STAFF REPORT

Department of Metropolitan Development Division of Planning Current Planning Section

Case Number: 2023-DV3-001
Address: 5505 and 5855 Brookville Road (approximate address)
Location: Warren Township, Council District #12
Zoning: I-4
Petitioner: AOZI Brookville Building I, LLC, by Joseph D. Calderon
Request: Variance of development standards of the Consolidated Zoning and Subdivision Ordinance to provide for the redevelopment of an industrial site and building expansion resulting in, collectively, multiple double-loaded and single-loaded rows of parking within the front yards of Irvington Avenue, Brookville Avenue and Arlington Avenue (parking in front of a building limited to one double-loaded row in Industrial Districts); and to provide for loading areas within the front yard of Brookville Road (not permitted), with 9-foot by 18-foot employee parking spaces (180-square foot parking spaces required) and deficient landscaping.

2023-DV3-001: Site Plan delivery vehicle and employee parking areas

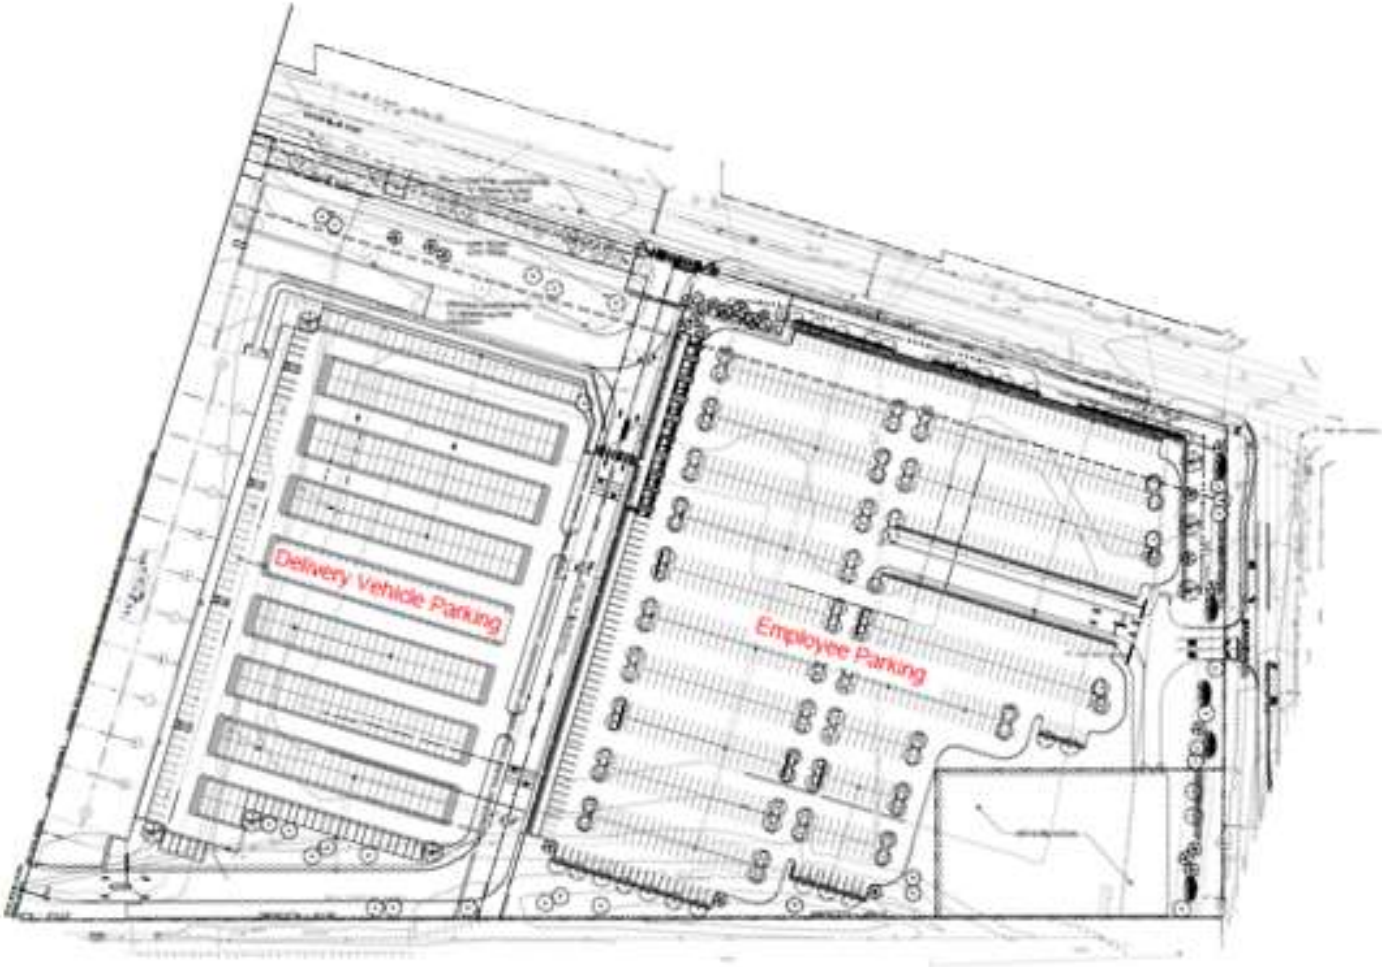
- ◇ The proposed site plan and landscape plan, indicates the employee parking area would be to the east of the warehouse building, with access limited to Arlington Avenue only. Staff is concerned with that amount of traffic generated for a single entrance and exit, especially during a shift change, that negative impacts will be imposed on adjacent properties. DPW and IMPD have both indicated that they would not support a traffic signal, either permanent or operating only during shift changes, at this location due to its proximity to the Brookville Road and Arlington Avenue signalized interchange, and for other traffic safety reasons.

- ◇ Therefore, a secondary exit and entrance is needed for the employee parking lot. DPW and Staff has proposed an internal connection from the employee parking lot, to the internal driveway that uses the existing entrance/exit on Brookville Road, which would help provide relief from the employee parking lot for both entering and exiting, especially during shift changes. The petitioner has not yet agreed to this recommendation. Staff, along with DPW and IMPD, feels strongly that this access is needed, and therefore will recommend denial of the petition in its entirety if it is not included in the site plan.

- ◇ The proposed parking areas in the front yard of Brookville Road and Arlington Avenue would provide multiple double-loaded and single-loaded rows of parking and would be similar to the parking areas that existed with the previous use. The parking area as proposed in the front yard of Irvington Avenue was previously approved with petition 2021-DV2-042. Additional landscaping above Ordinance requirements along the Brookville Road and Arlington Avenue frontages are proposed and would help mitigate any negative impact on the adjacent residential protected district. The deficient landscaping would primarily be located within the delivery vehicle parking lot, located immediately to the east of the warehouse structure. The employee parking would provide Ordinance complaint landscaping with approximately 62 shade trees for the parking lot interior landscaped area, where 57 would be required. However, none of the proposed landscaping has been identified with a planting schedule.

The variance grant shall be subject to an amended site plan, to be submitted for Administrator's Approval, prior to the issuance of an Improvement Location Permit. At a minimum, the amended site plan shall provide a vehicle access connector from the employee parking lot and accessing the proposed curb cut entrance/exit from Brookville Road.

- ◇ Therefore, if approved, Staff is requesting approval be subject to an amended site plan, to be submitted for Administrator's Approval, prior to the issuance of an Improvement Location Permit. That at a minimum, the amended site plan shall provide a vehicle access connector from the employee parking lot and accessing the proposed curb cut entrance/exit from Brookville Road.
